# **Planning Committee Addendum**

**Date:                      Wednesday 22 November 2023**

<b>2/02</b>	<b>Perwell Court, Alexandra Avenue, Rayners Lane, HA2 9ED</b>
	<p><b>Include the bold text and remove the below stricken through bold text within the ‘REASON FOR THE RECOMMENDATION’ section.</b></p> <p>The proposal would not constitute Garden Land Development, it would contribute towards housing stock within the Borough and the quality of accommodation for the future. It would not detract from the character and appearance of the host building, street scene and area in a wider context. It would provide a suitable quality of accommodation for future occupiers without unduly impacting neighbouring residential amenity. It is not considered to result in significantly adverse traffic and parking impacts. The development’s proposed refuse storage arrangements are considered to be acceptable. The development is not considered to be susceptible to harmful flood risk and is not considered to unduly exacerbate flood risk elsewhere. Insufficient detail has been provided on the development’s compliance with Secured by Design requirements additional detail on this can be requested and secure

01 Site Plan as proposed  
PL-101 1:250 @ A3

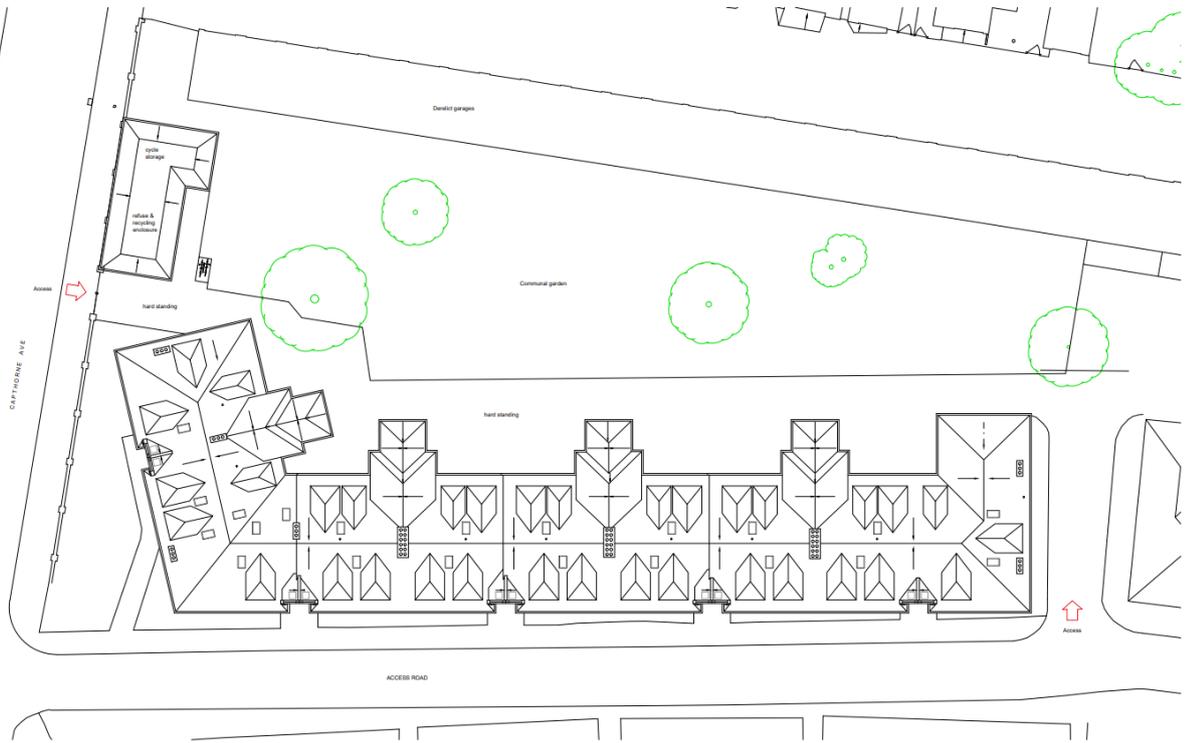
**Substitute the Proposed Site Plan drawing within Appendix 4 (Plans and Elevations) for the following drawing.**

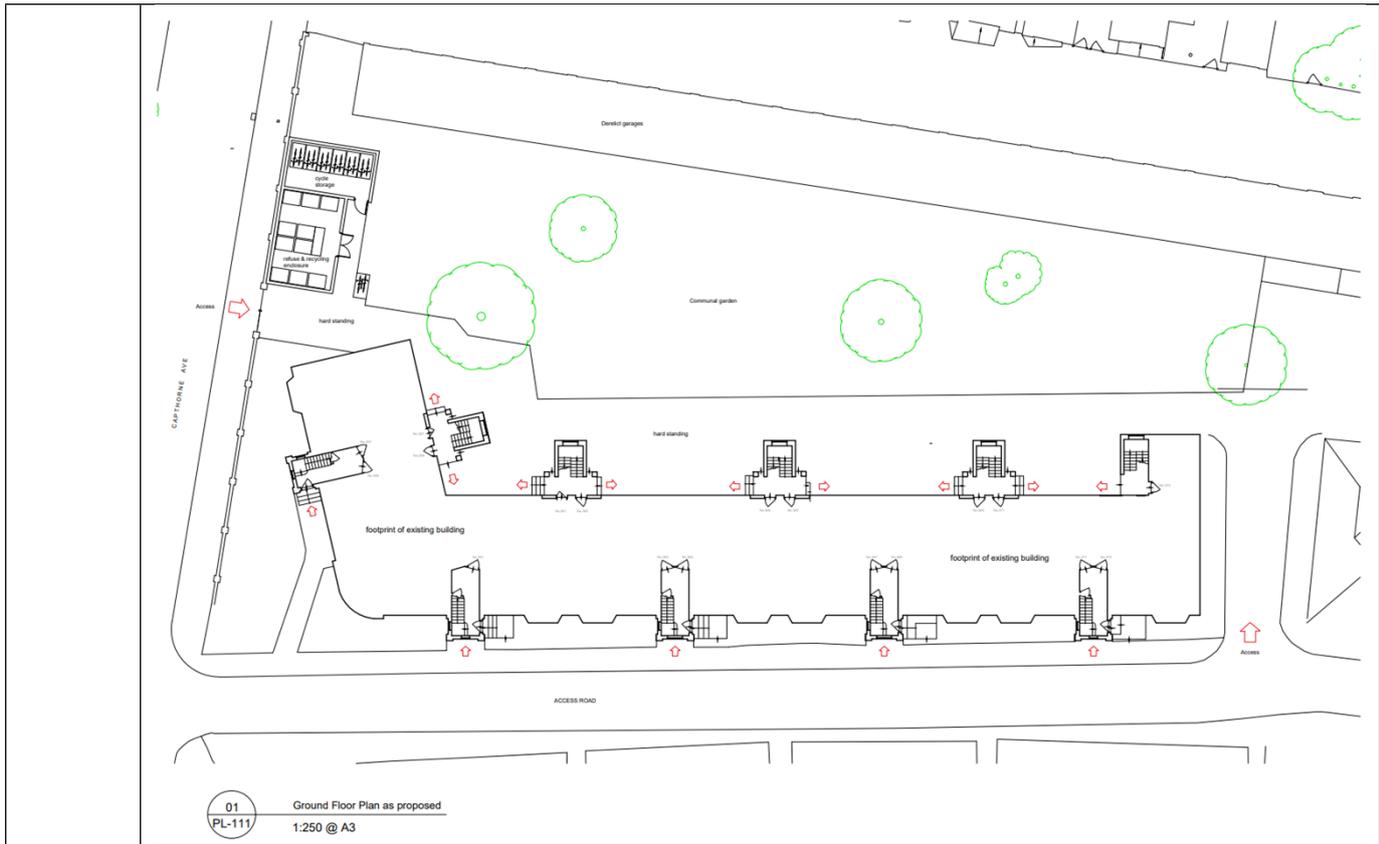
**Substitute the Proposed Ground Floor Plan drawing within Appendix 4 (Plans and Elevations) for the following drawing.**
